**From:** Kitchen, Robert [robert.kitchen@pgnmail.com]  
**Sent:** Friday, June 29, 2012 8:47 AM  
**To:** Habib, Donald  
**Cc:** Rose, Dana  
**Subject:** DRAFT Levy FSAR Org Charts  
**Attachments:** LNP\_FSAR\_FIG13AA\_201.pdf; LNP\_FSAR\_FIG13\_01\_201.pdf; LNP\_FSAR\_FIG13\_01\_203.pdf; bPECOLA-2-LI-012-0013-R3-F1.pdf; PECOLA-2-LI-012-0013-R3-F1.pdf; aPECOLA-2-LI-012-0013-R3-F1.pdf

Don – As discussed, attached are the current LNP FSAR organization charts and the DRAFT changes to reflect the Duke – Progress Energy merger. These changes will also be reflected in the QAPD. Let me know if you have questions. We can discuss on the public call on Thursday, 7/5/12.

Progress Energy Florida  
 Levy Nuclear Plant  
 Units 1 and 2  
 Part 2, Final Safety Analysis Report

FIGURE 13AA-201

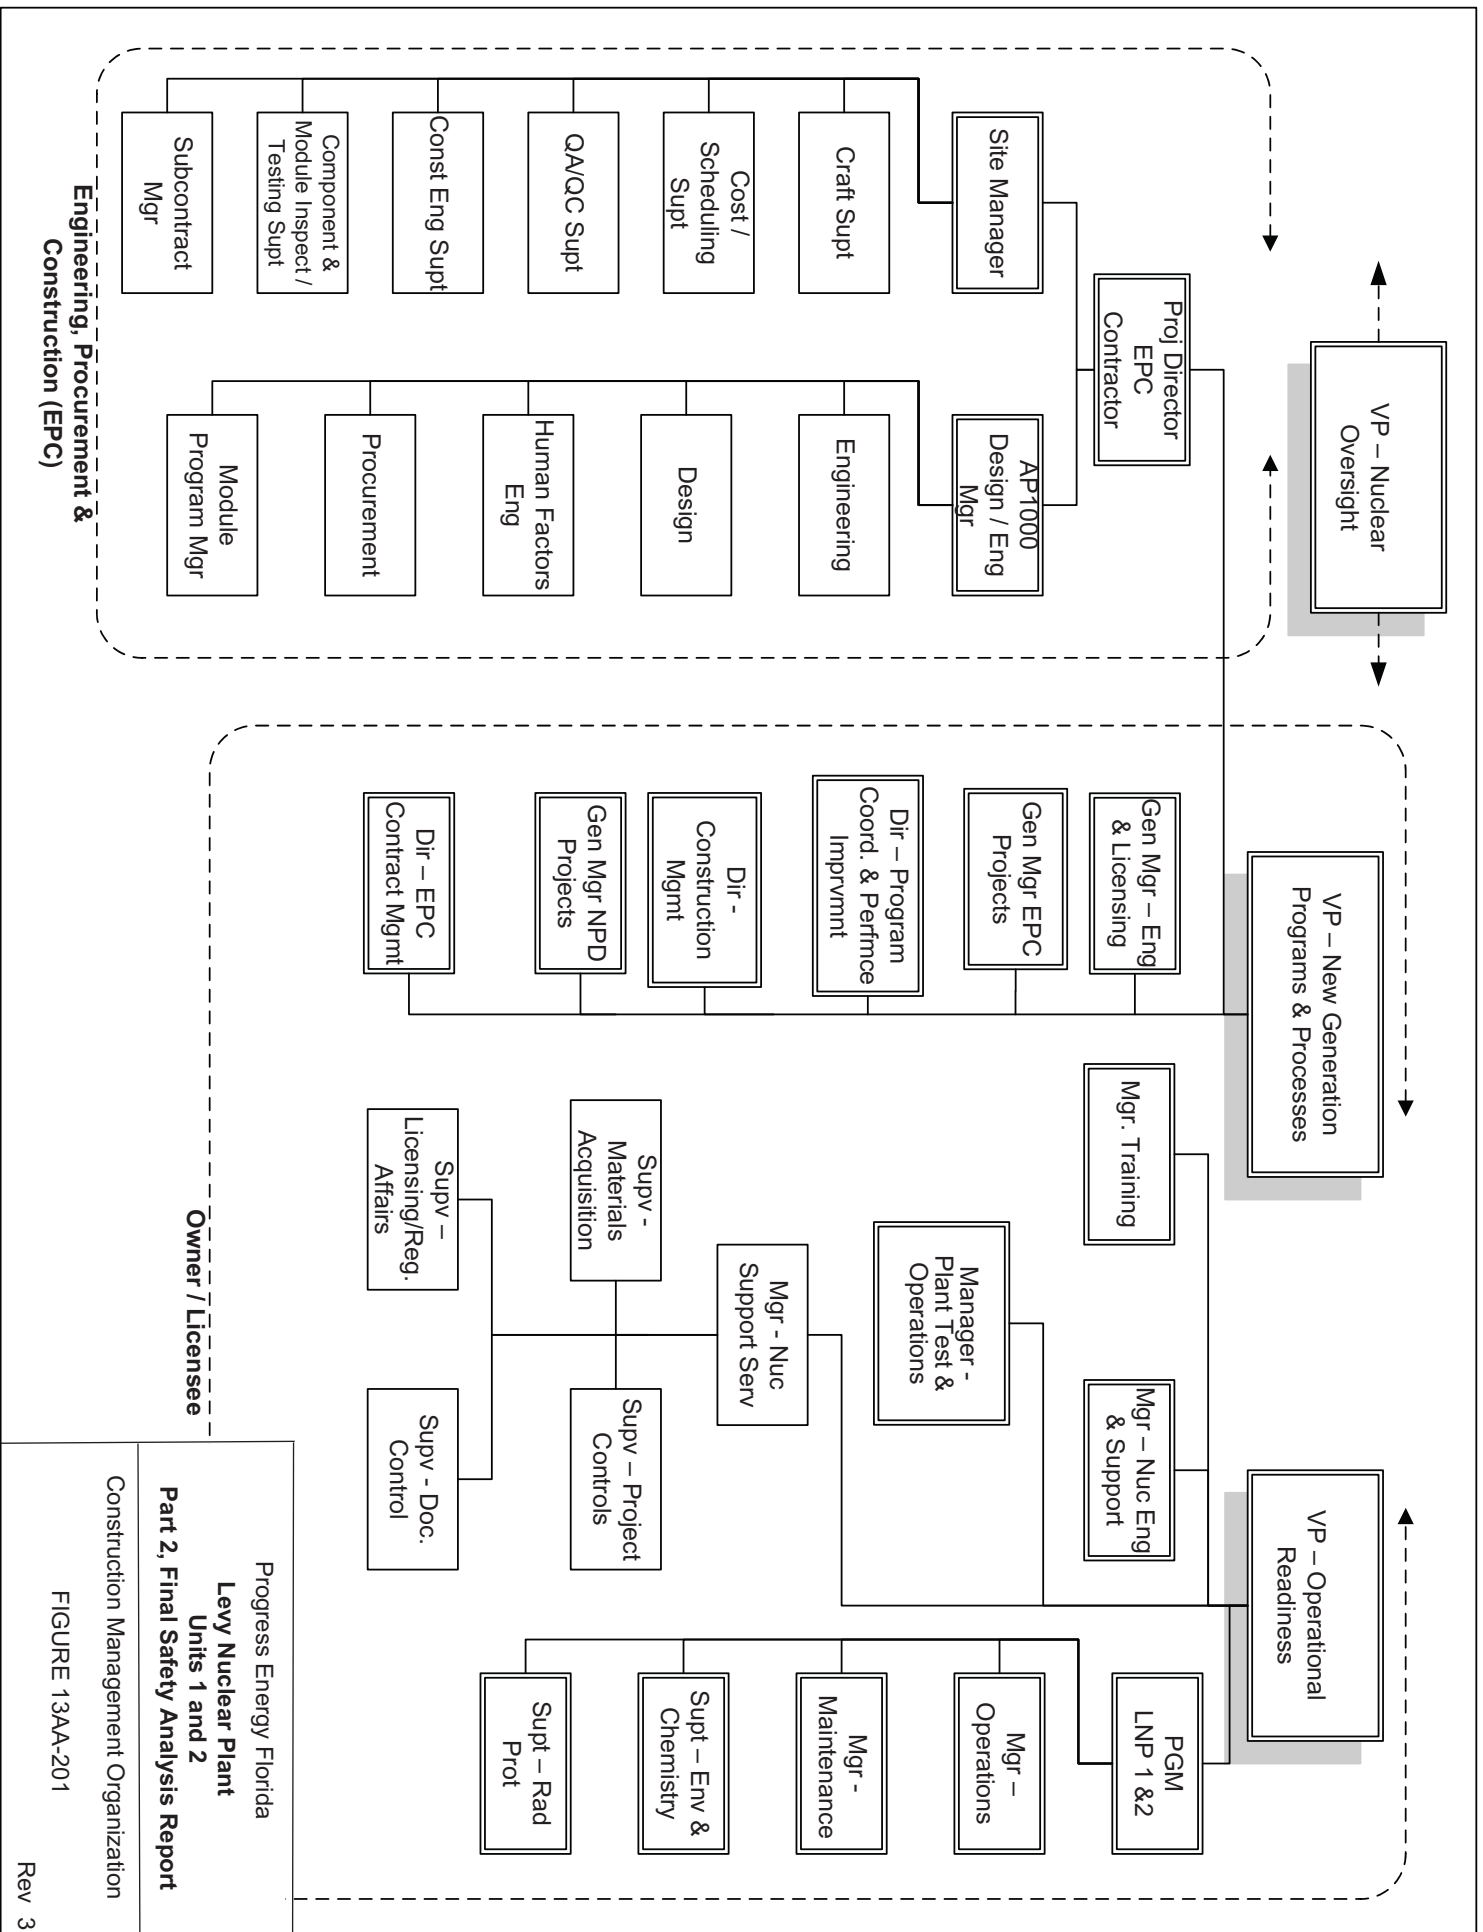
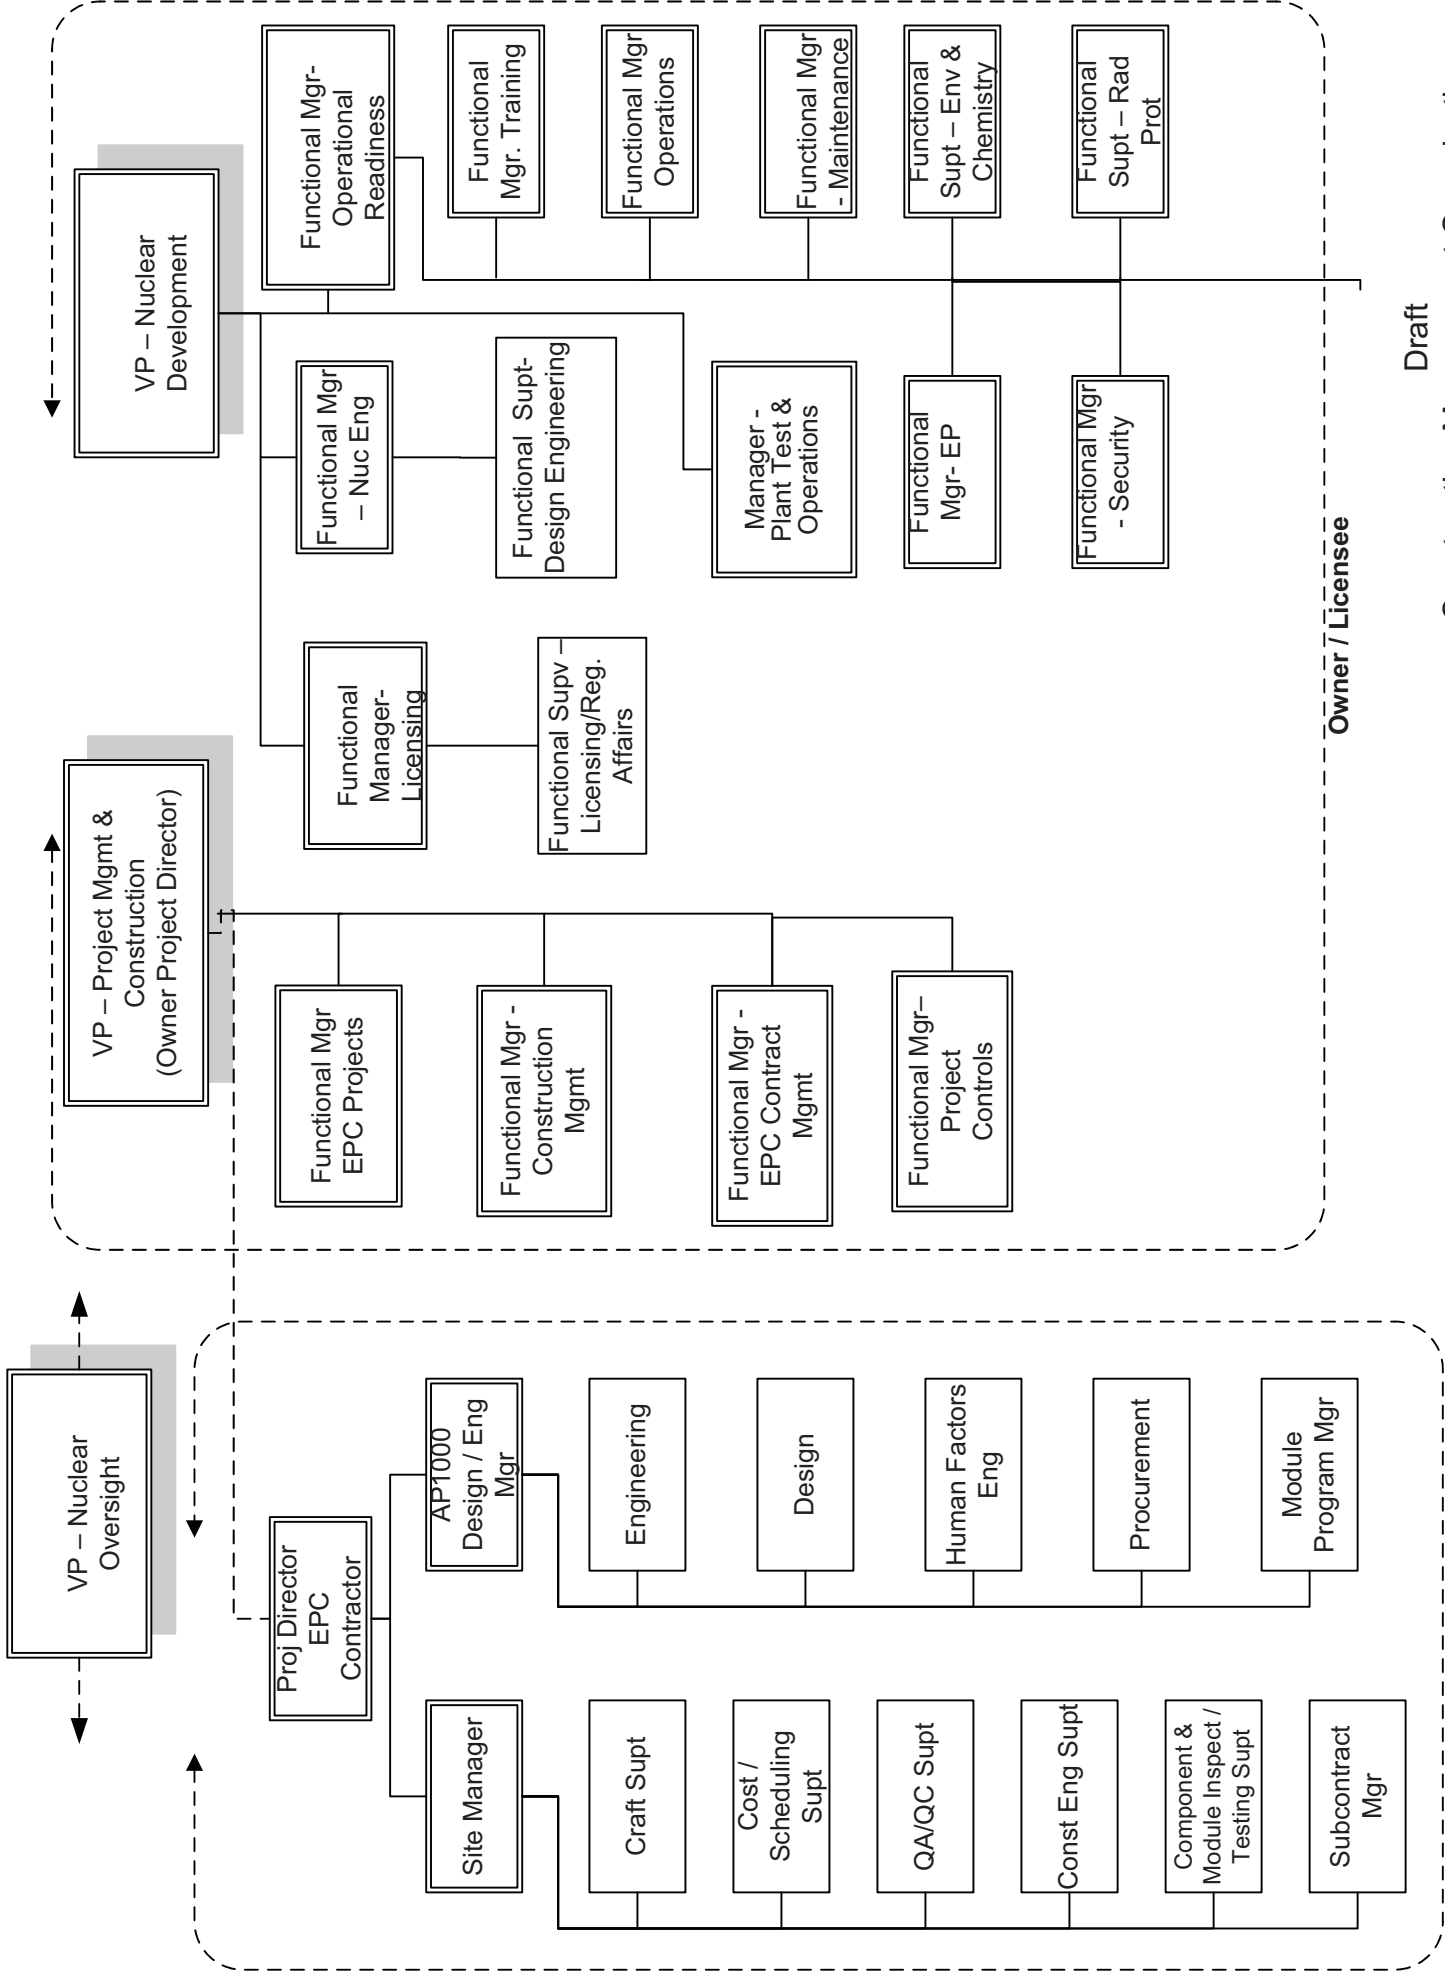
Construction Management Organization  
Figure 13AA - 201

Plant Management Organization  
 FIGURE 13.1-201

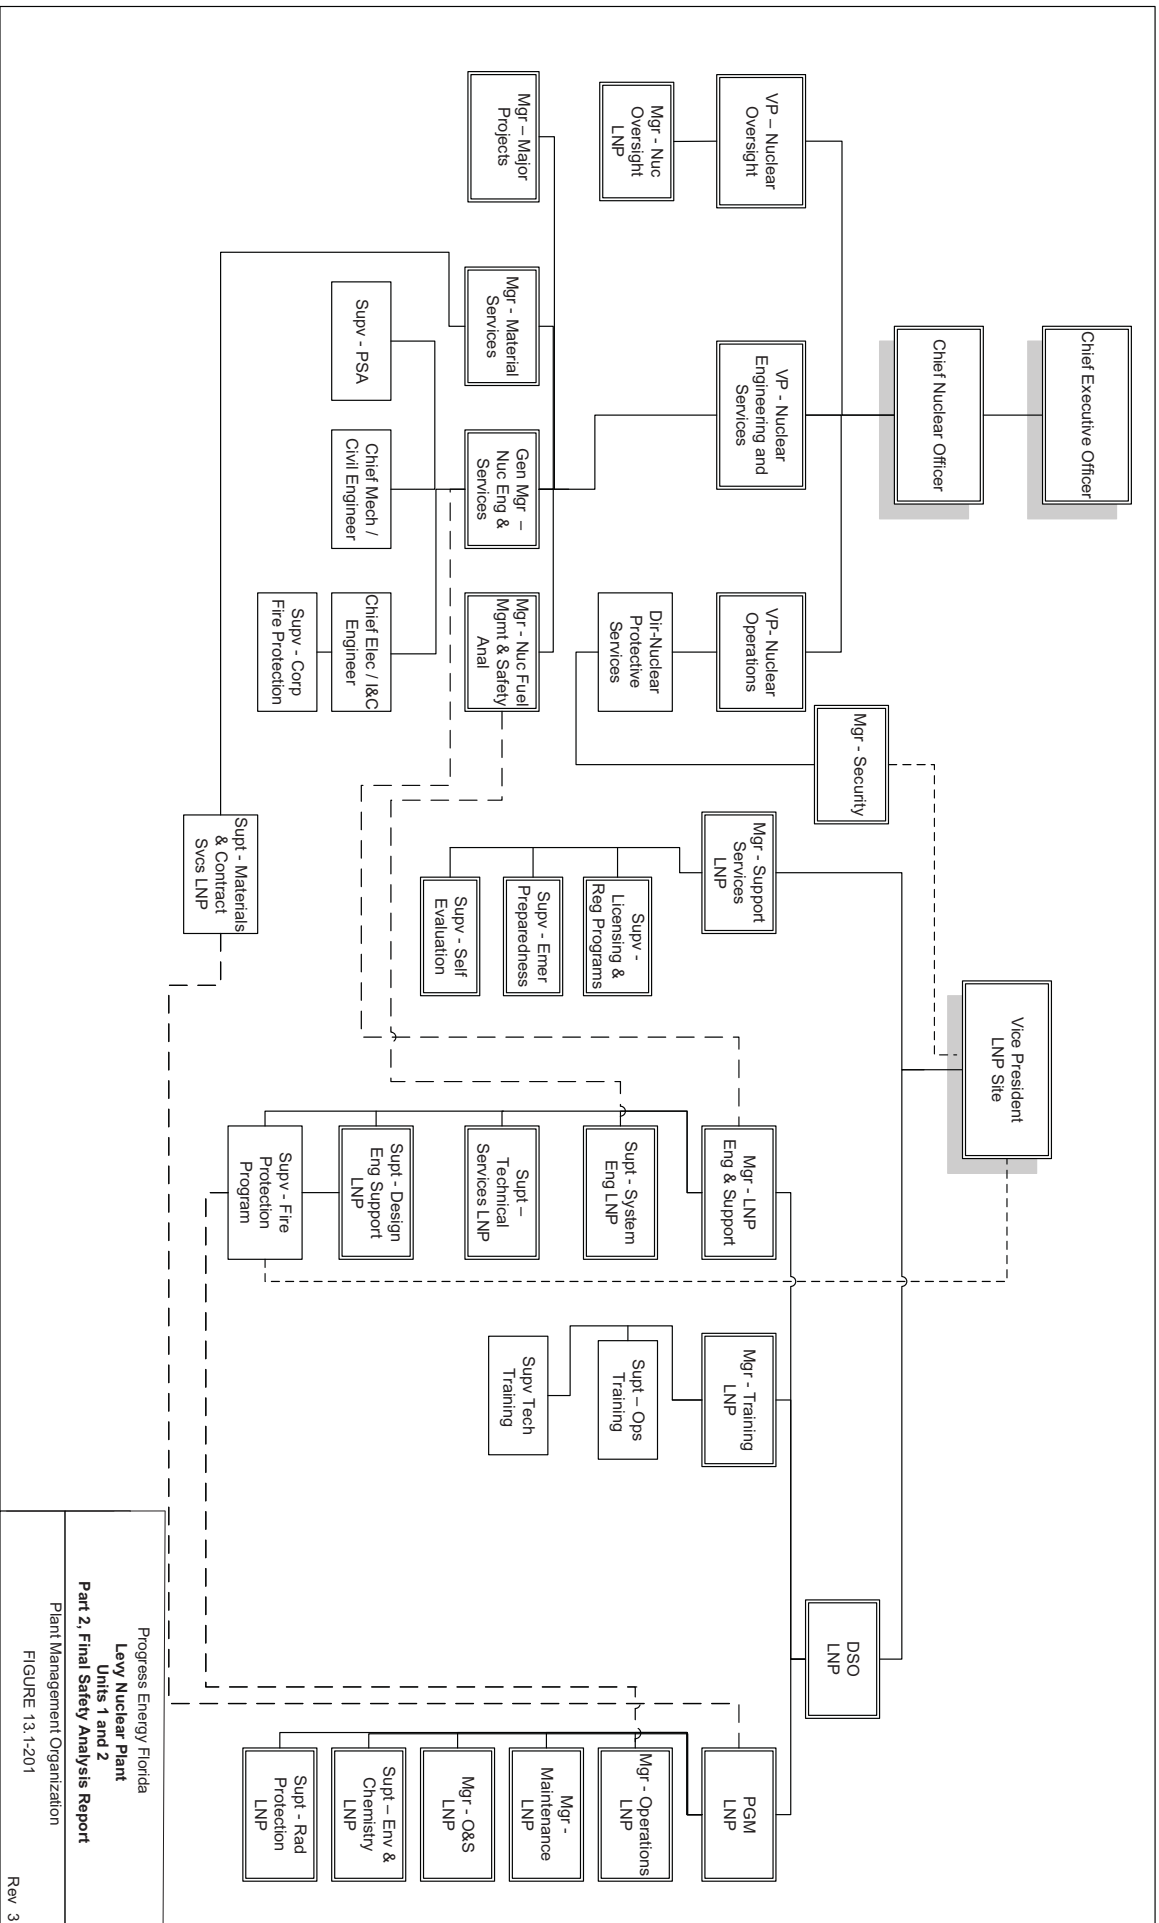
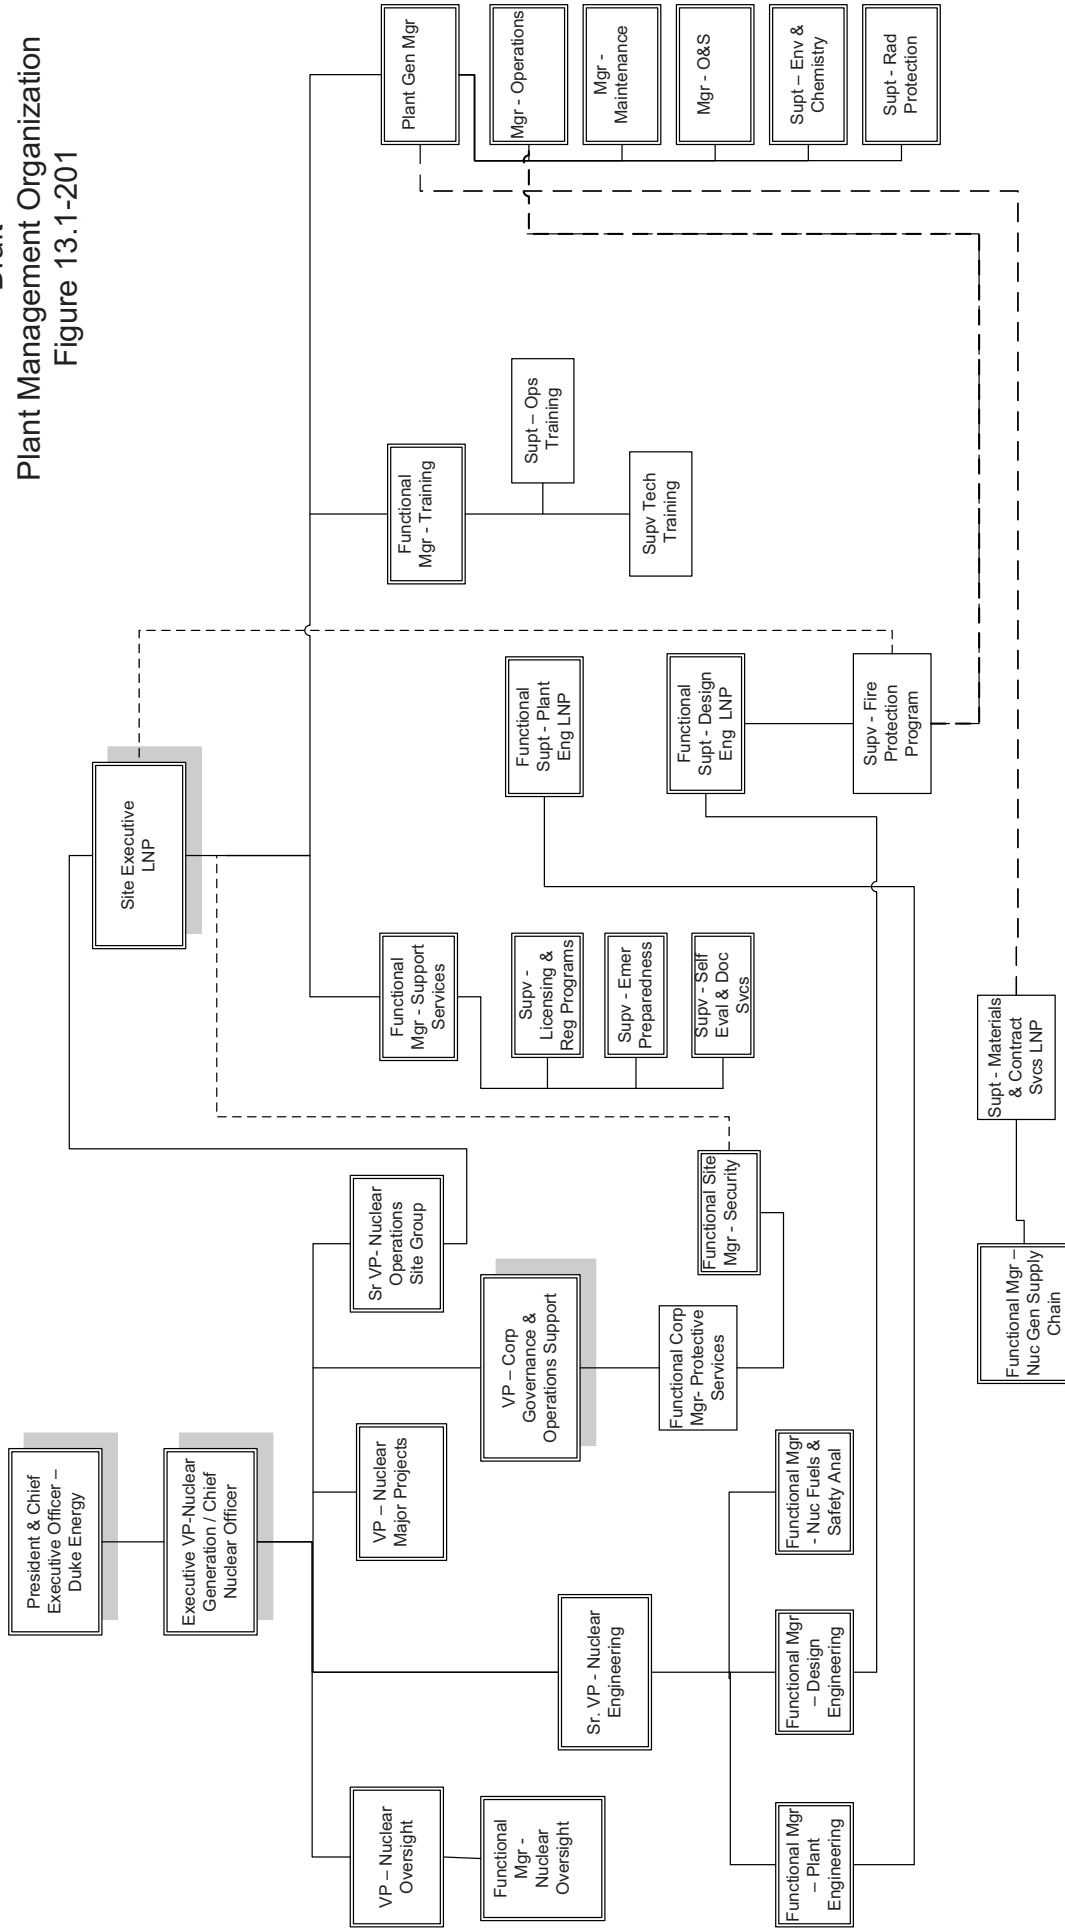
Draft  
 Plant Management Organization  
 Figure 13.1-201
